FALCON SERVICE BULLETIN

FALCON 900

No 372-R1

**LIGHTING
EXTERIOR LIGHTING
ELECTRICAL BONDING OF WHELEN FIN TIP ANTI-
COLLISION LIGHT**

Figure 1: ELECTRICAL BONDING ON AIRCRAFT WITH FAIRINGS F50B319BX AND FGFB319A2 (A3)

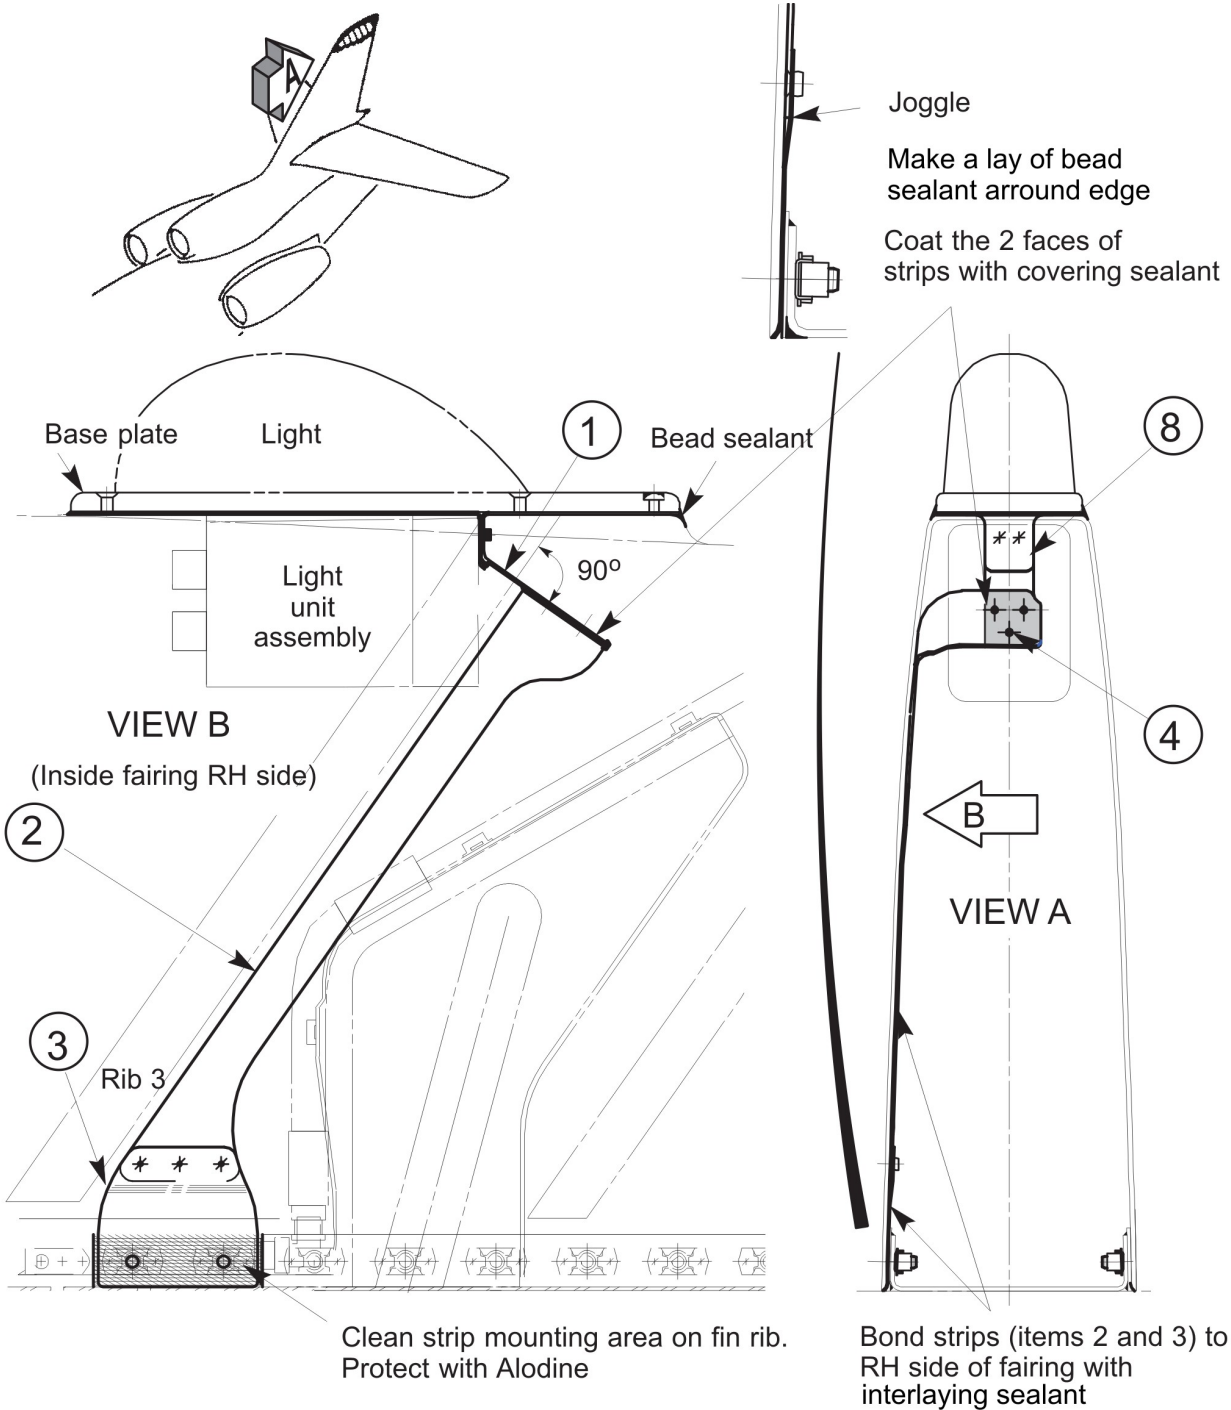
- (1) Cut out the run outs of the compound seal to obtain a plane mounting surface.
- (2) Set the mounting-base bonding strip (item 1), equipped with shim (item 8), into place on the fairing. Attach with two screws.

- (3) Fold the tab of the strip to a 90° angle with respect to the fairing's rib.
- (4) Pin the strip assembly (items 2 and 3) to the fairing.
- (5) Position the strip assembly (items 2 and 3) in contact against the RH side panel of the fairing and on strip (item 1). If necessary, rework the shape of the strips to obtain proper contact.

- (6) Remove the strip assembly (items 2 and 3).
- (7) Install double-sided adhesive tape on the face coming in contact with bonding strip (item 1).
- (8) Re-install strip assembly (items 2 and 3). Pin to hold in contact against the fairing.

- (9) Install strip (item 1) over the strip assembly, pressing firmly at the contact area).
- (10) Remove the strip assembly (items 1, 2 and 3).
- (11) Counterdrill bonding strip (item 2) to a diameter of 0.1 in (2.5 mm). Disconnect the strips and discard the adhesive tape, remove all remaining adhesive.

- (12) Enlarge the holes drilled in the strips to a diameter of 0.126 in (3.2 mm). Assemble bonding strips (items 1 and 2) using rivets (item 4). Coat the faces of the strips with **covering sealant** making a bead at the contour edge with **bead sealant**.

- (13) Clean the contact surfaces of the light unit assembly, of the strips, and of the fairing using **MEK**.
- (14) Coat the strip assembly (items 2 and 3) with **interlaying sealant**.

- (15) Set the strip assembly and the light unit assembly into place in the fairing without making electrical connections and attach the light assembly to the fairing. Smooth out the PR in excess around the strips (items 2 and 3).

- (16) Use a shim to wedge strip assembly (items 2 and 3) in contact against the fairing's wall. Allow to cure.
- (17) Temporarily position the fairing at the fin tip and mark the location of strip (item 3).

- (18) Strip the paint off the fin tip rib at the location marked for strip (item 3). Protect the stripped area with **alodine**.

Figure 2: ELECTRICAL BONDING ON AIRCRAFT WITH FAIRINGS F50B319, (A1), (A2) AND FGFB319, (A1)

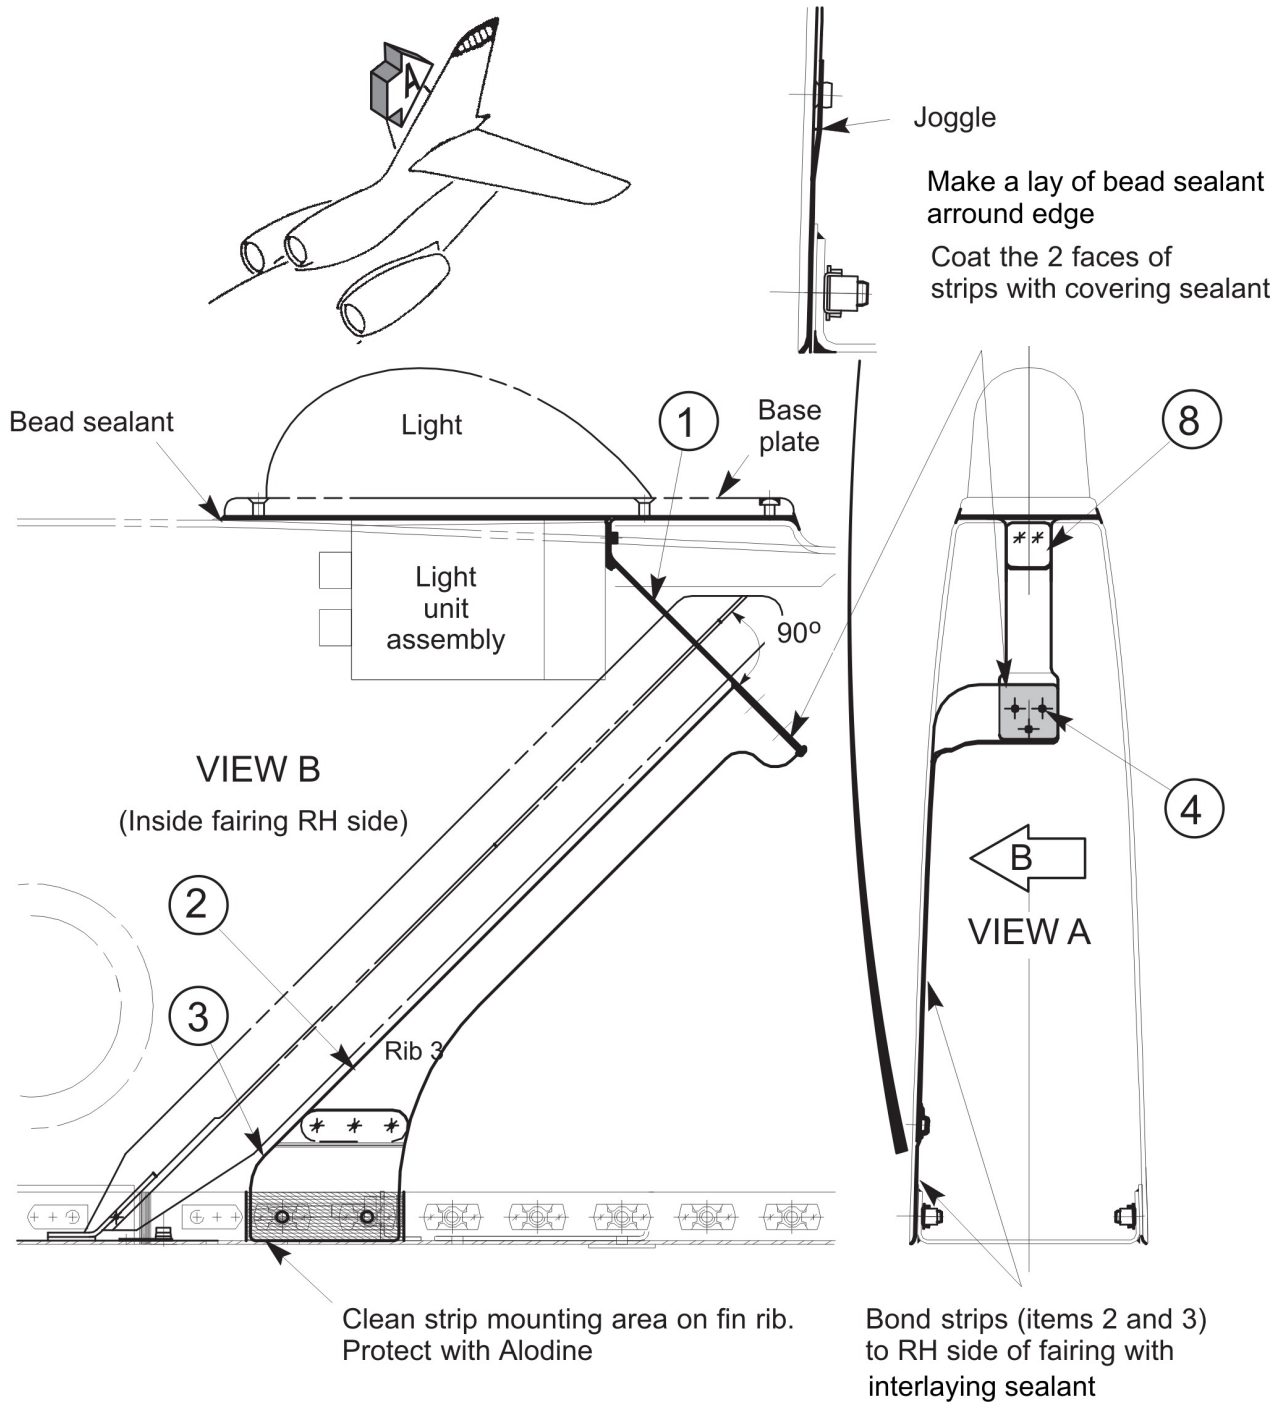
In accordance with **fig. 1** or **fig. 2** depending on the P/N of the existing fairing:

Figure 3: AIRCRAFT F900B WITH MODIFICATION MF900 M1682 APPLIED IN PRODUCTION LINE

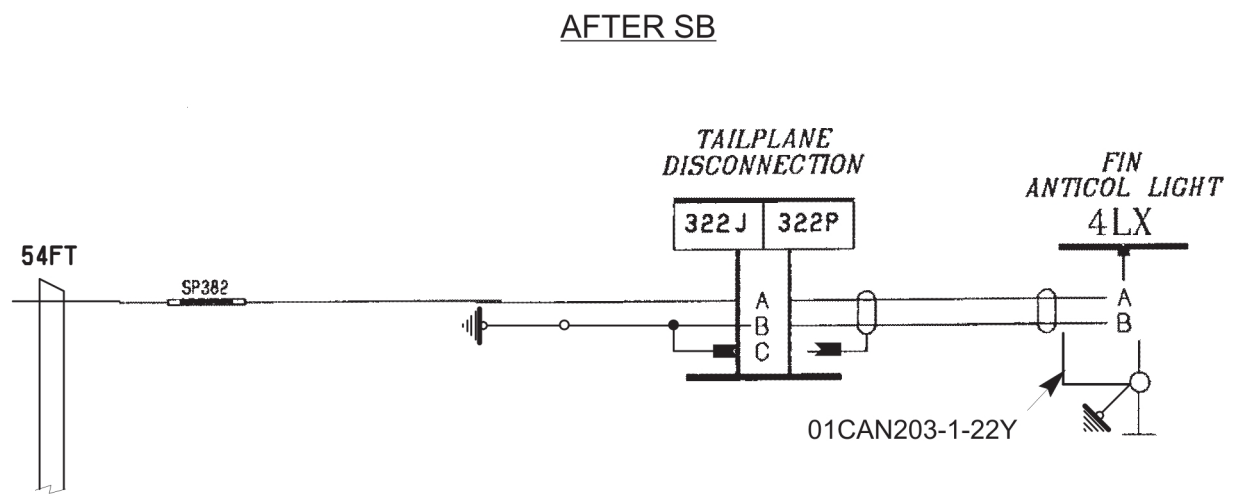
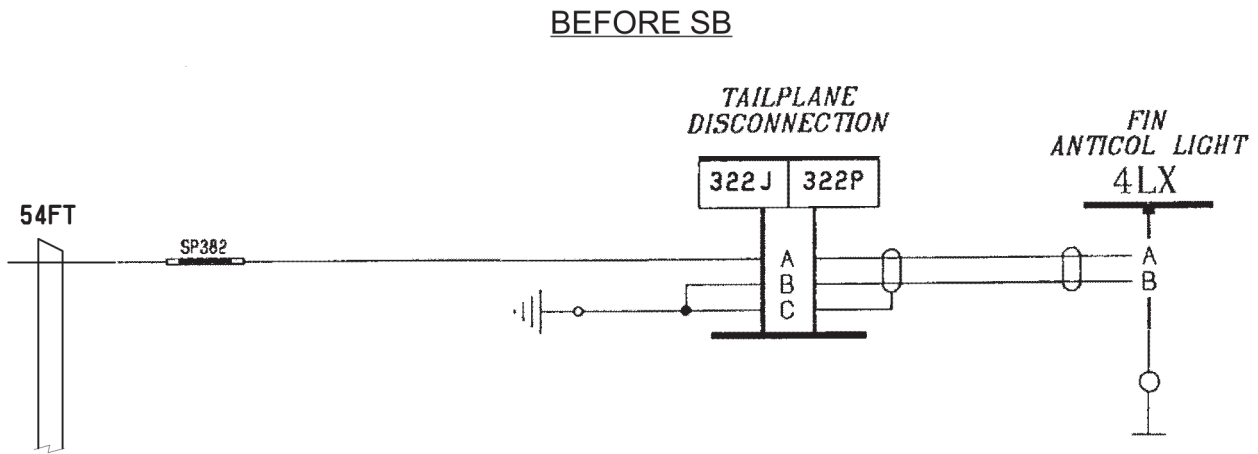
Modify the shield connection in accordance with instructions depicted hereafter and using **fig. 3**, **fig. 4** and **fig. 5** in accordance lights' installation on the aircraft.

Dimension A:

- Connector with front extraction: 1.38 in (35 mm).
- Connector with rear extraction: 1.97 in (50 mm).

Self-soldering sleeves must be staggered at the extremity of the wiring assemblies so as to prevent a bulge on the bundle.

Figure 4: AIRCRAFT F900B WITH F900-182 APPLIED

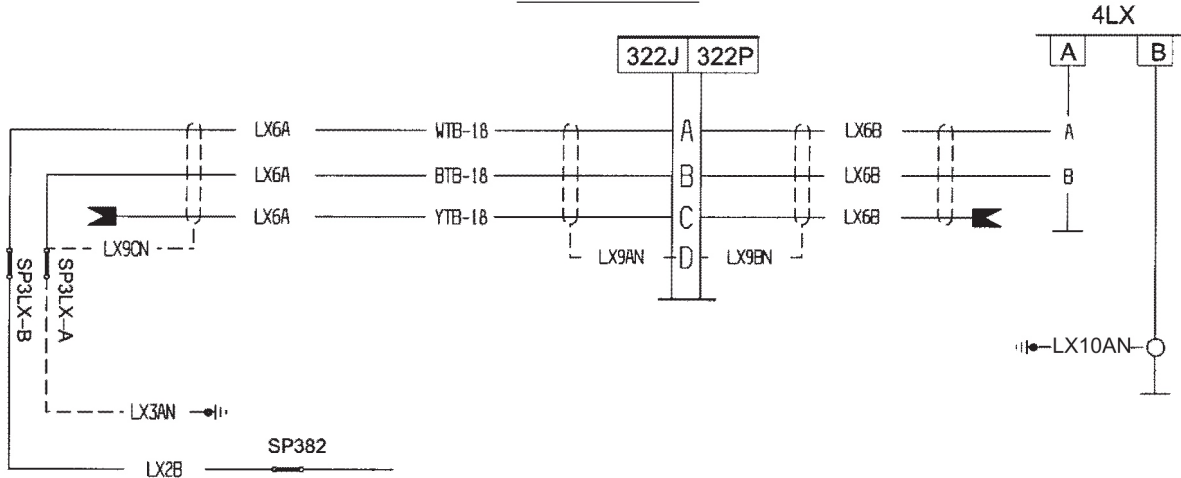
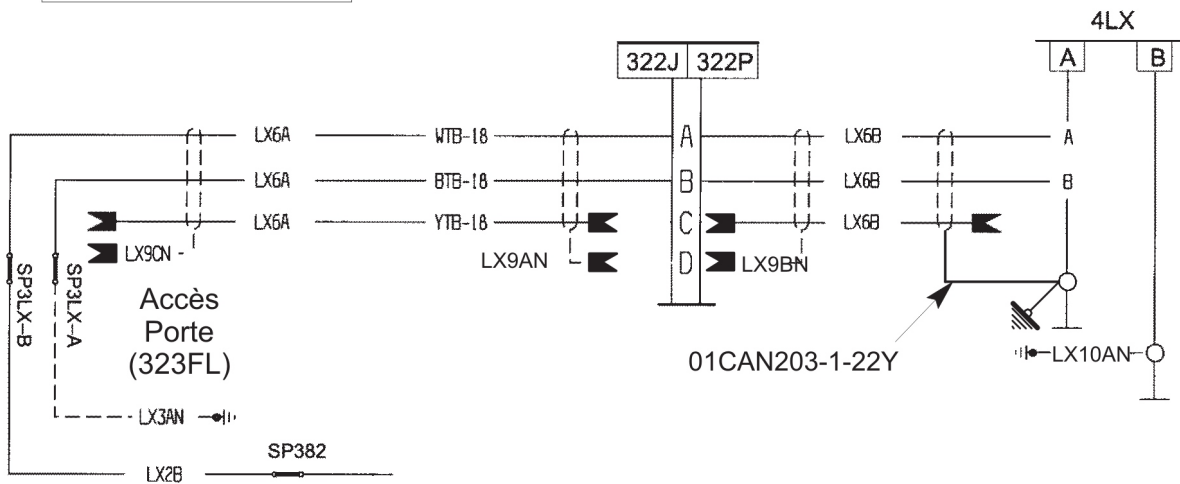
INCORPORATE INTO
WD 33-44-02

Figure 5: AIRCRAFT F900C S/N 179 AND SUBSEQUENT

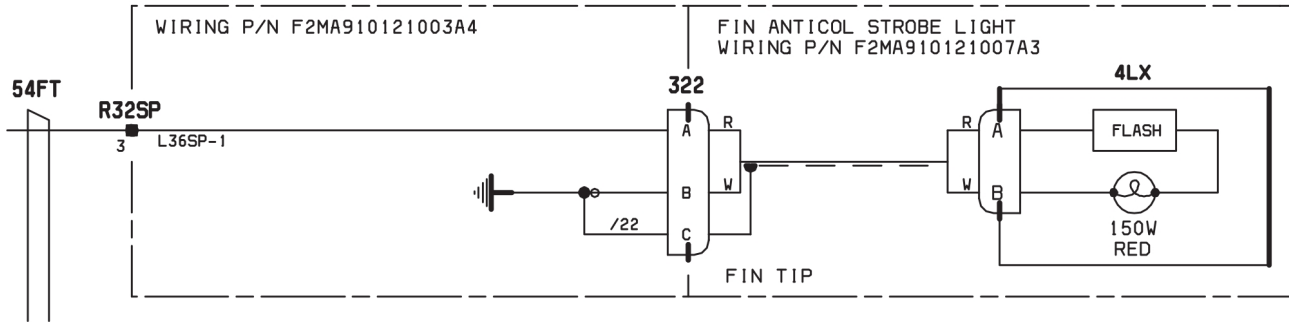
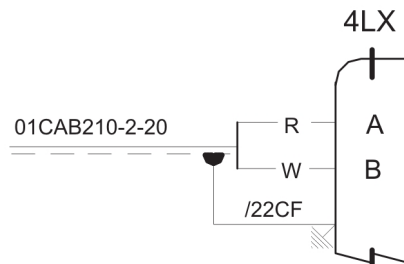
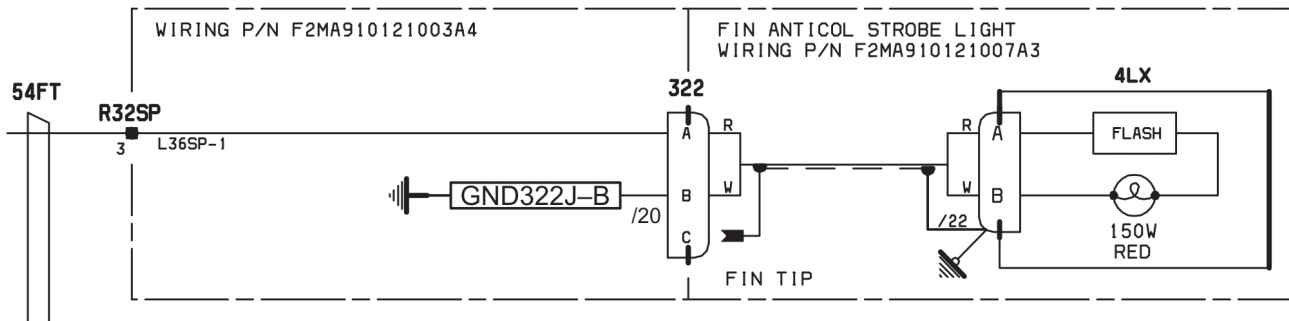
INCORPORATE INTO
WD 33-42-00

Figure 6: FAIRING P/N F50B319BX OR FGFB319A2 (A3) - RE-ROUTING THE WIRING - AIRCRAFT WITH WIRING ROUTED OVER RIB 2

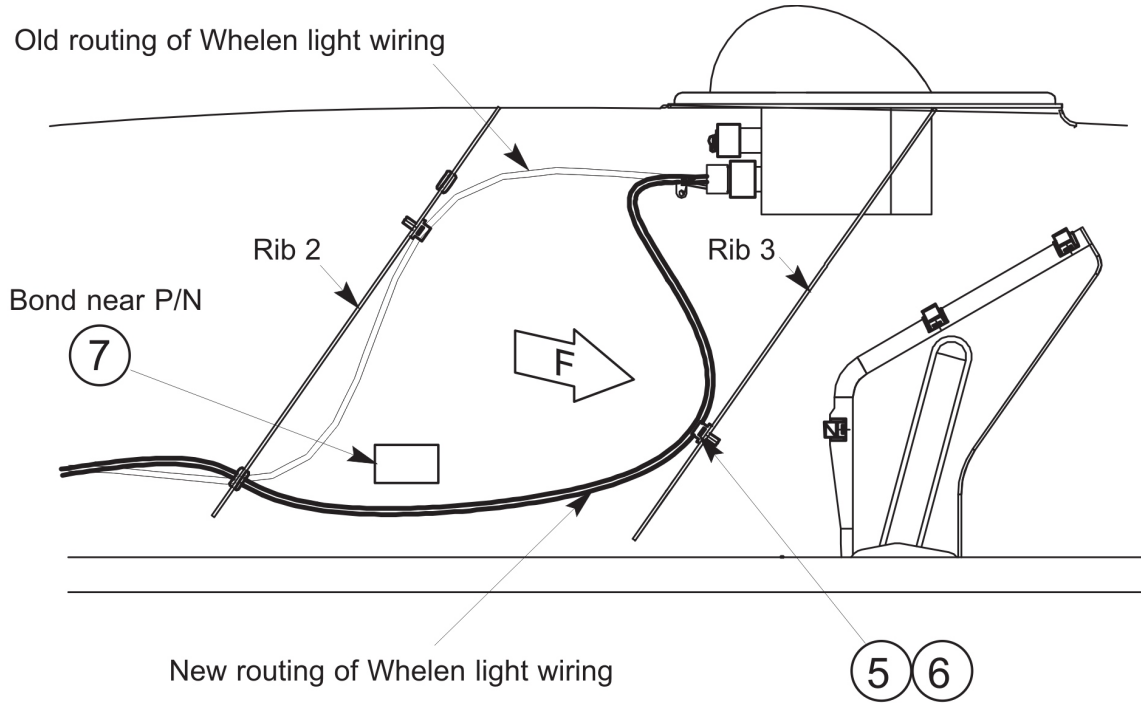
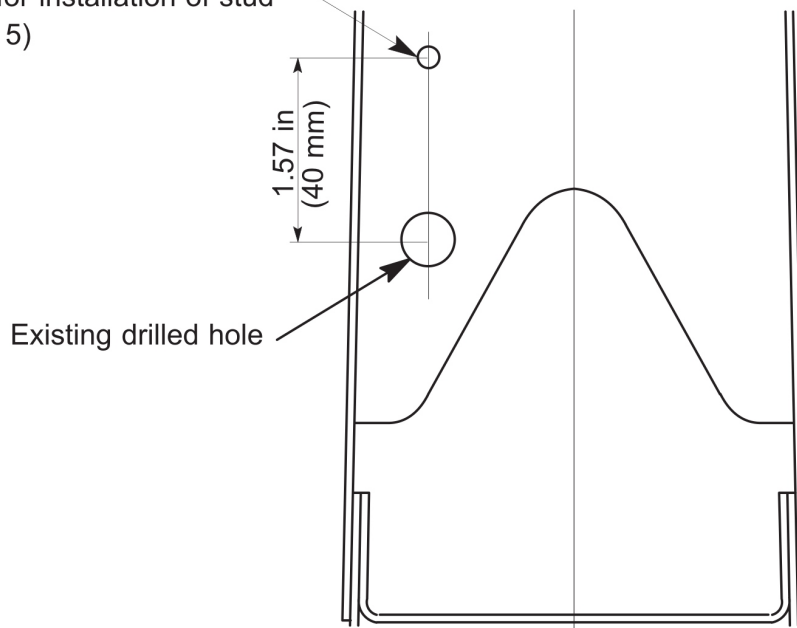
In accordance with **fig. 6**:

- (1) Remove the WHELEN light unit assembly.
- (2) Drill a 0.19 in (4.9 mm) diameter hole through the rib of the fairing.
- (3) Install new clamping stud (item 5) on rib 3.
- (4) Unclamp the wiring from rib 2.
- (5) Clamp the wiring to rib 3.
- (6) Connect connector (4LX) to the WHELEN light.
- (7) Attach the light unit assembly to the fairing.
- (8) Install the gasket, the glass cover, and the retainer (Refer to [IPC fig. 33-40-10-50](#) , items 346, 345, 342).
- (9) Apply **bead sealant** around the retainer.

Drill 0.19 in (4.9 mm) diameter hole for installation of stud (item 5)

Figure 7: FAIRING P/N F50B319BX OR FGFB319A2 (A3) - RE-ROUTING THE WIRING - AIRCRAFT WITH WIRING ROUTED AROUND THE BACK OF FAIRING

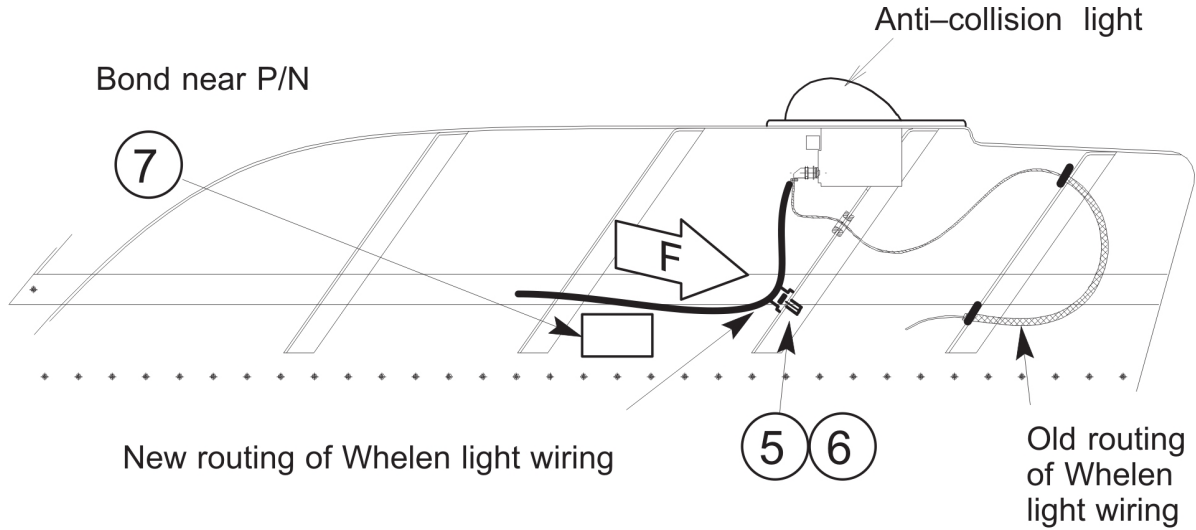
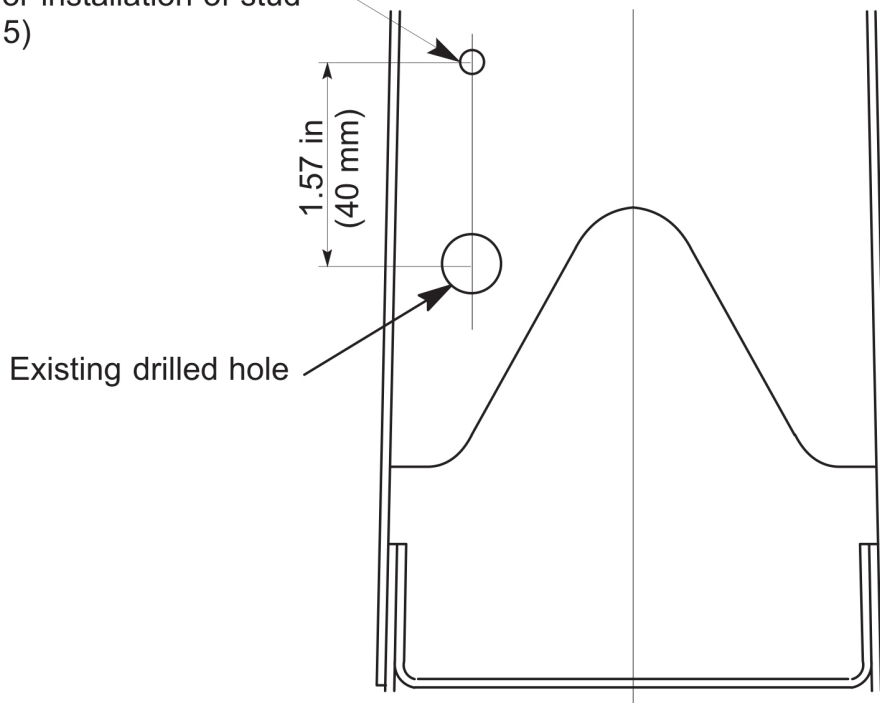
In accordance with **fig. 7** (Fairing P/N F50B319BX or FGFB319A2, (A3)) or **fig. 8** (Fairing P/N F50B319, (A1), (A2) or FGFB319, (A1))

- (1) Remove the WHELEN light unit assembly.
- (2) Drill a 0.19 in (4.9 mm) diameter hole through the rib 3 of the fairing.
- (3) Install new clamping stud (item 5) on rib 3.
- (4) Remove contacts from connector (4LX).
- (5) Adjust the wiring length for proper re-routing in accordance with **fig. 7**.
- (6) Fit the cut wires with new contacts and insert them into connector (4LX).
- (7) Clamp the wiring to rib 3.
- (8) Connect connector (4LX) to the WHELEN light.
- (9) Attach the light unit assembly to the fairing.
- (10) Install the gasket, the glass cover, and the retainer (Refer to [IPC fig. 33-40-10-50](#) , items 346, 345, 342).
- (11) Apply **bead sealant** around the retainer.

Drill 0.19 in (4.9 mm) diameter hole for installation of stud (item 5)
